STATE OF VERMONT AGENCY OF TRANSPORTATION

PROPOSED IMPROVEMENT TOWN OF PERU COUNTY OF BENNINGTON VT ROUTE 11 (MINOR ARTERIAL)

Record Plans

DIRECTOR OF PROJECT DELIVERY	APPROVED DATE 12/31/2014
PROJECT MANAGER : KEN UPMAL, P.E.	
PROJECT NAME : PERU	
PROJECT NUMBER : STP SCR(4)	
SHEET 1 OF 45 SHEETS

**SPECIAL PROVISION (STOP LOG SYSTEM)**

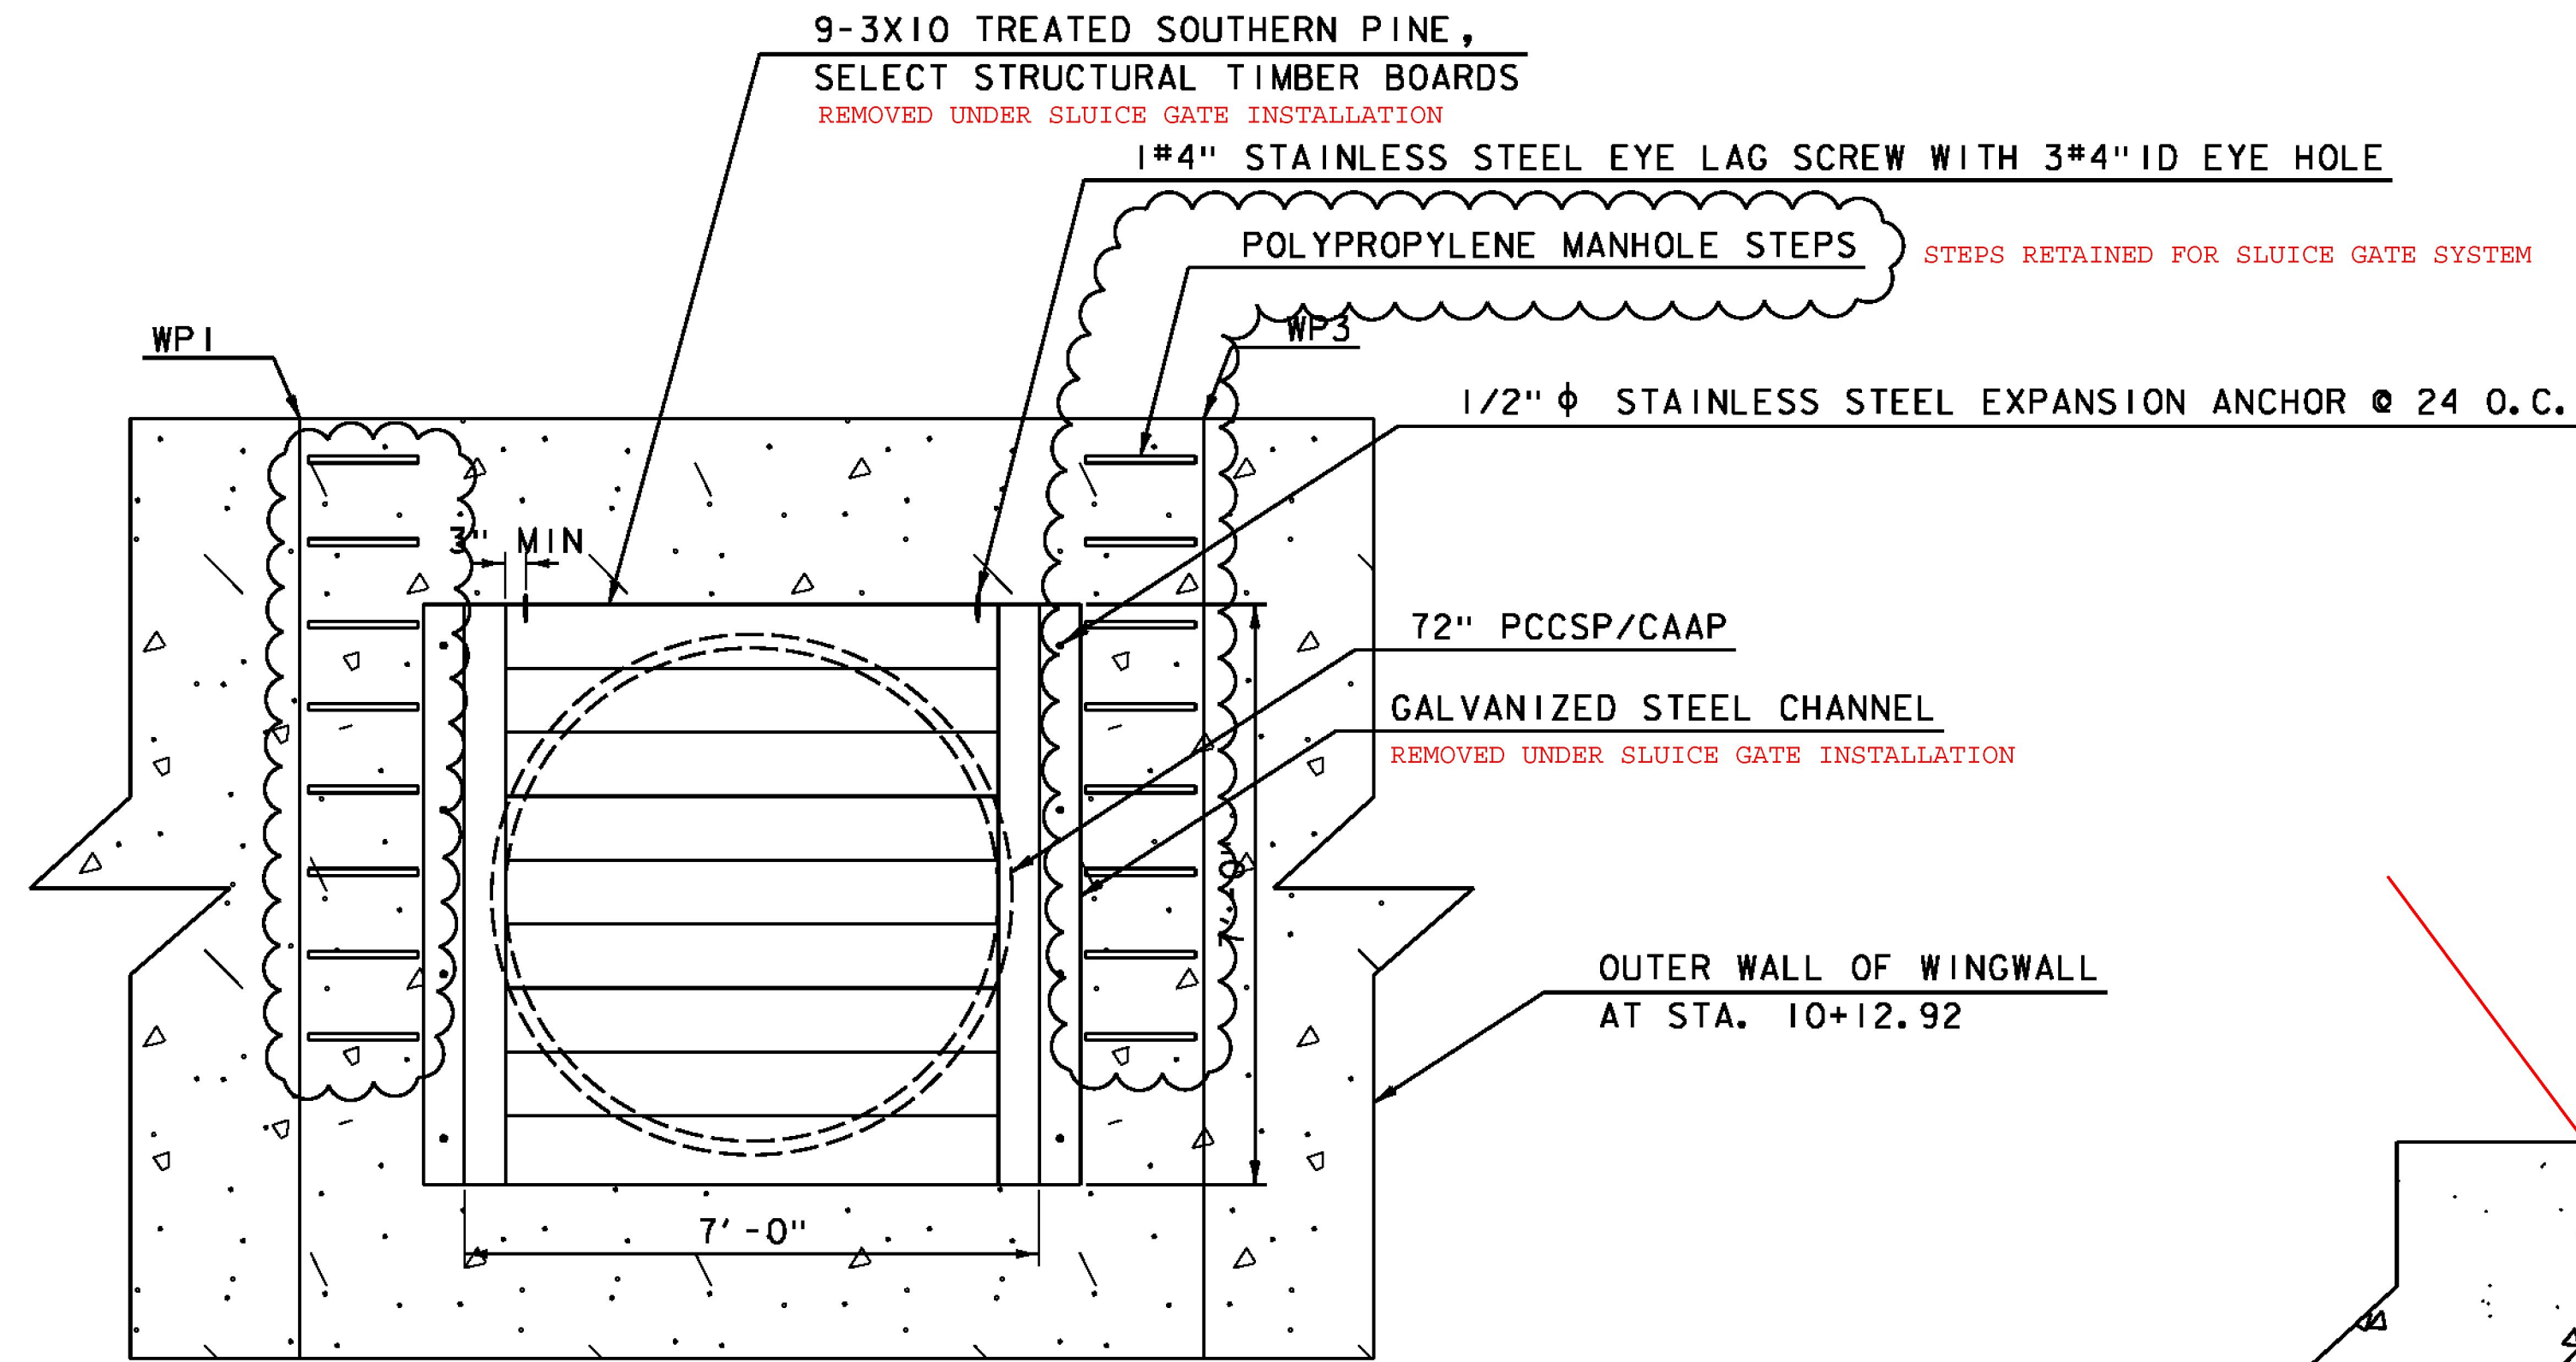
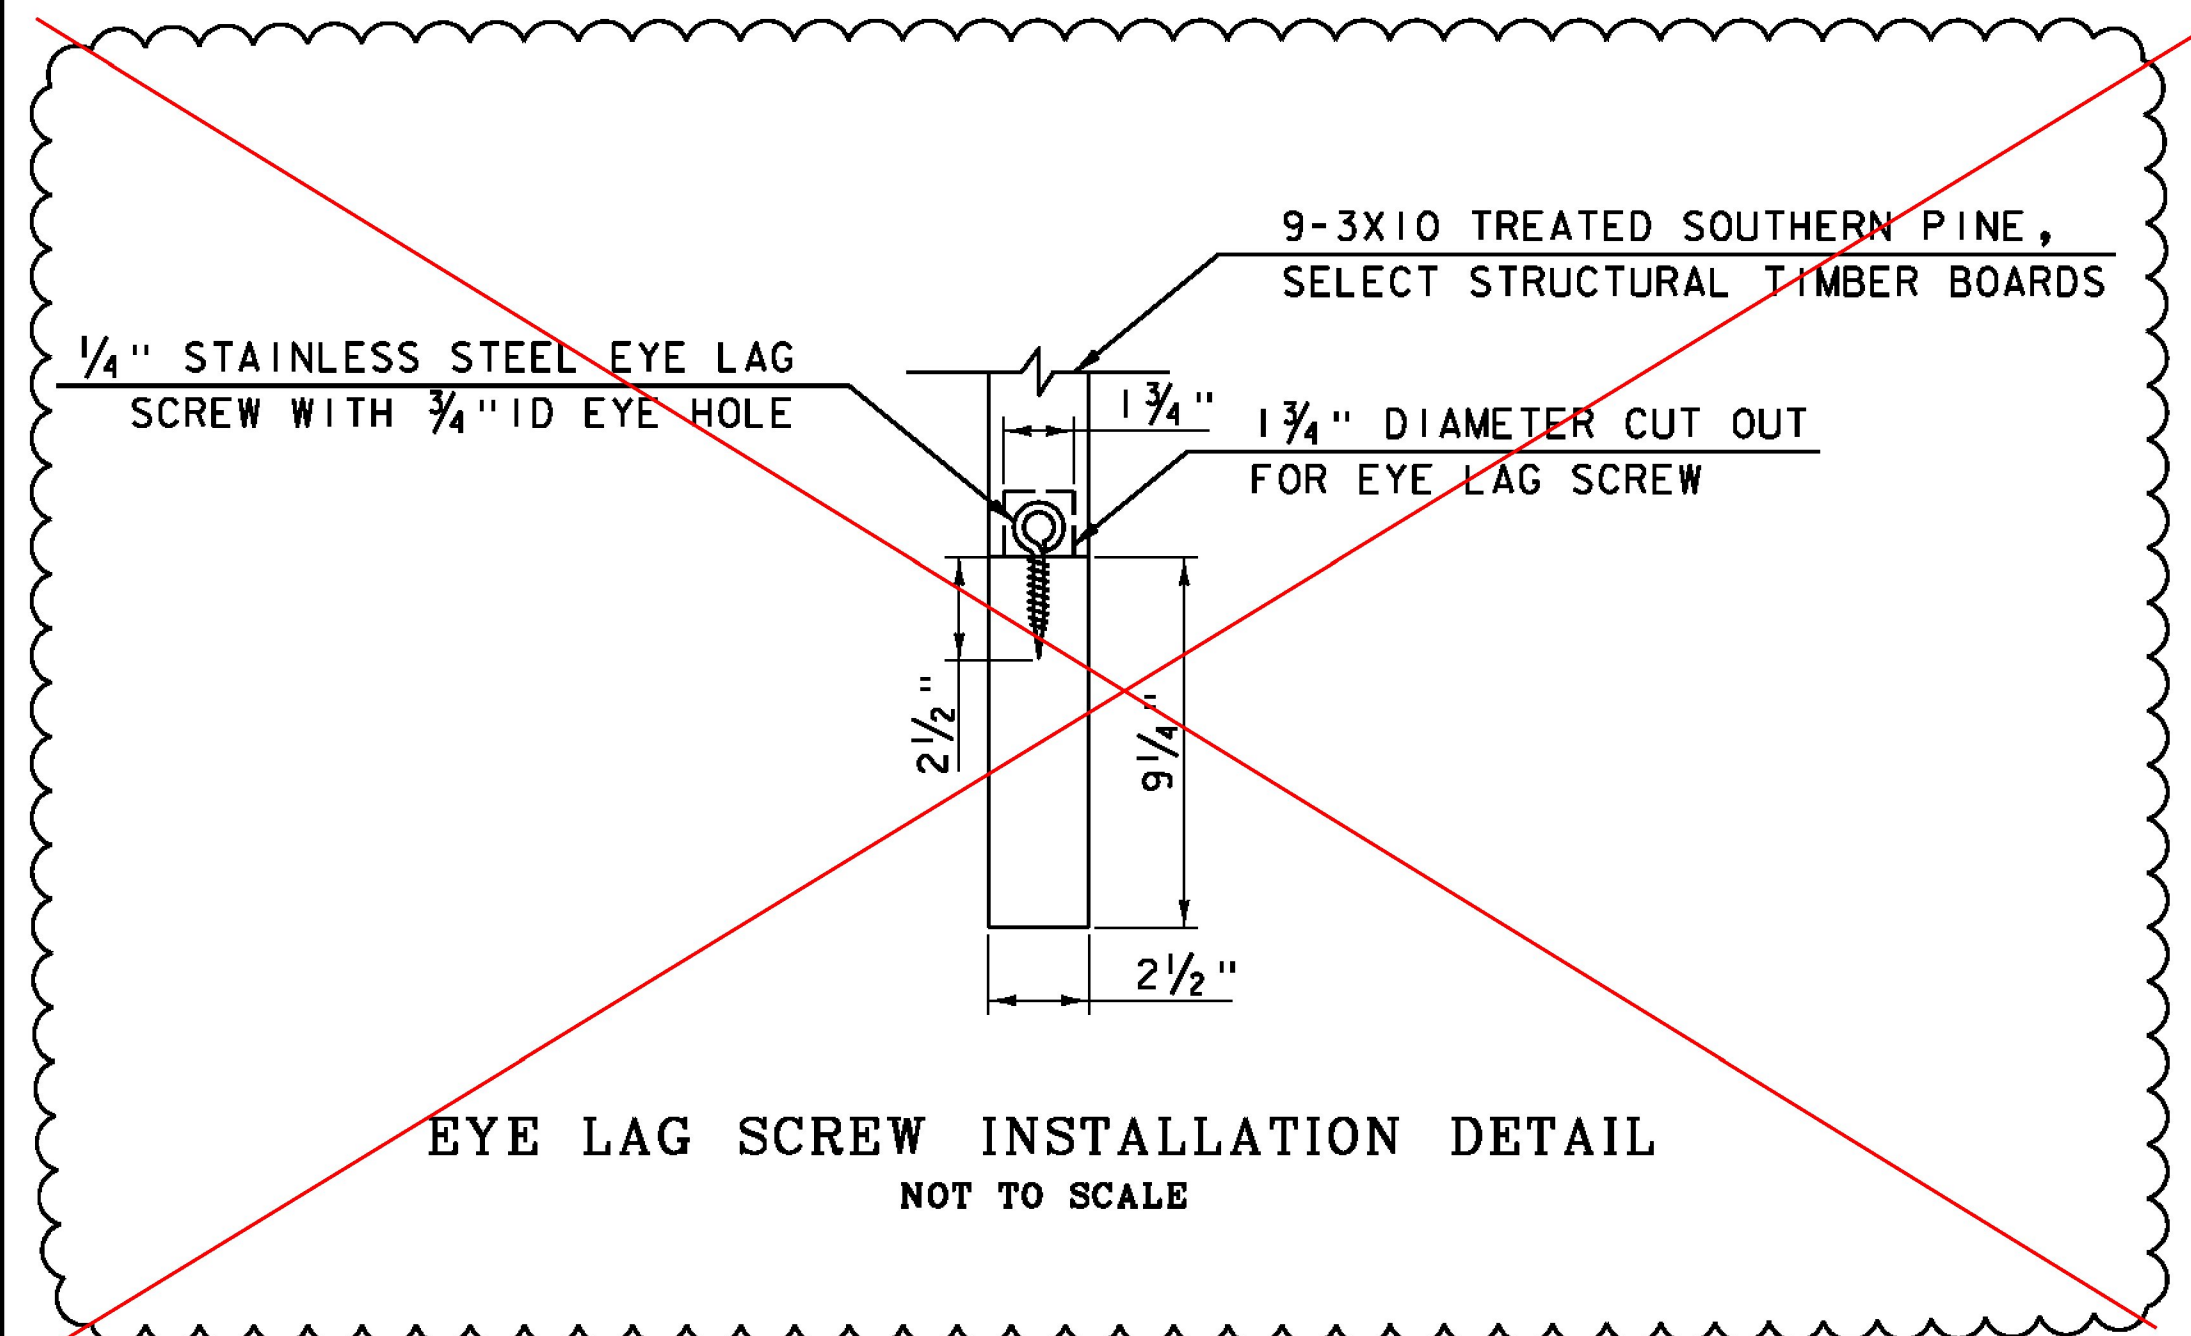
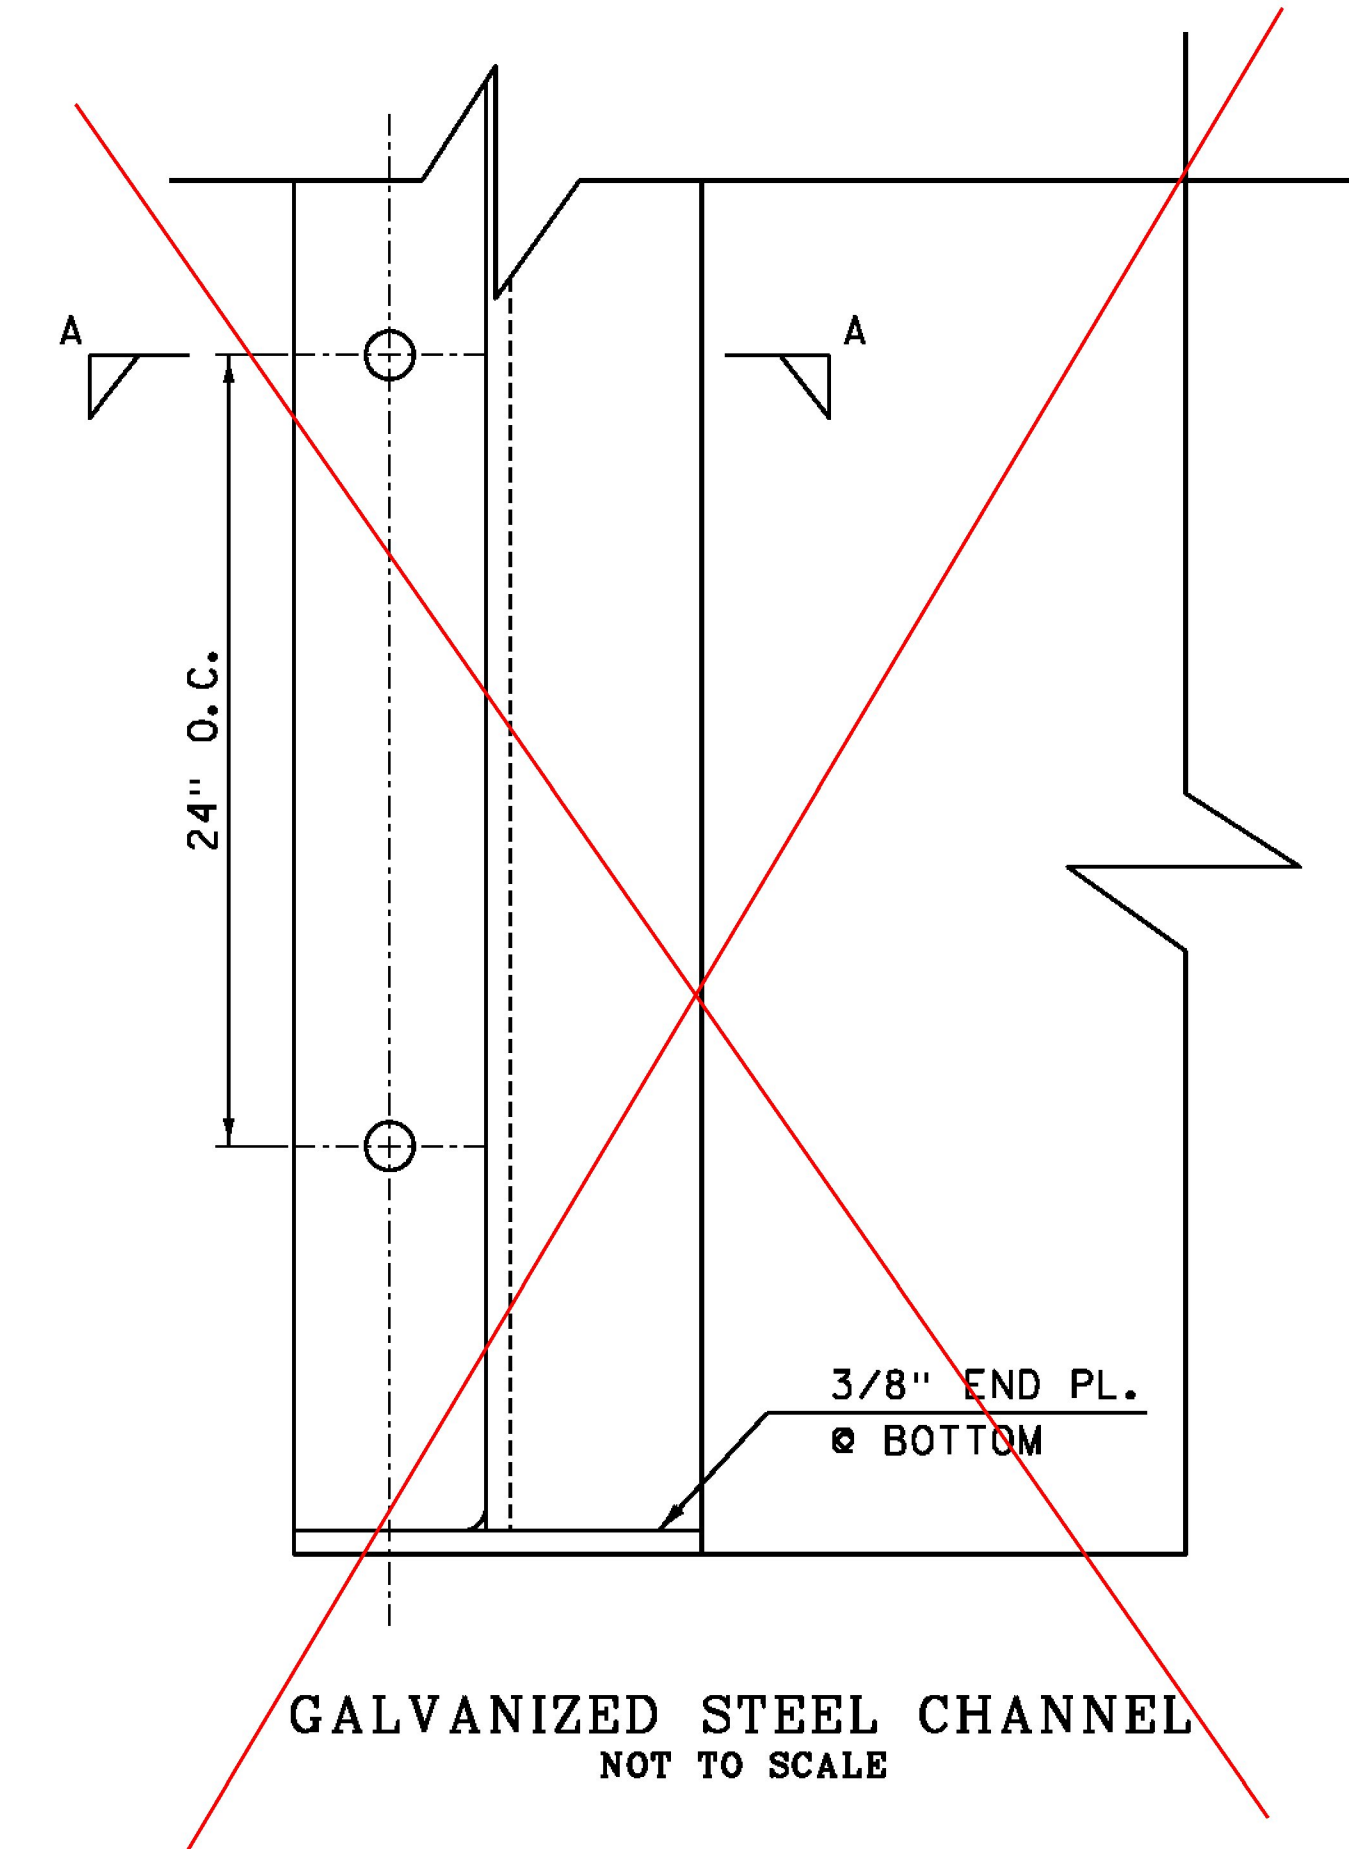
**NOTE:**  
 STOP LOG SYSTEM INITIALLY INSTALLED; DUE TO FAILURE,  
 SYSTEM WAS REPLACED IN JUNE 2018 WITH A SLUICE GATE.  
 SEE FOLLOWING SHEETS FOR SLUICE GATE SYSTEM.
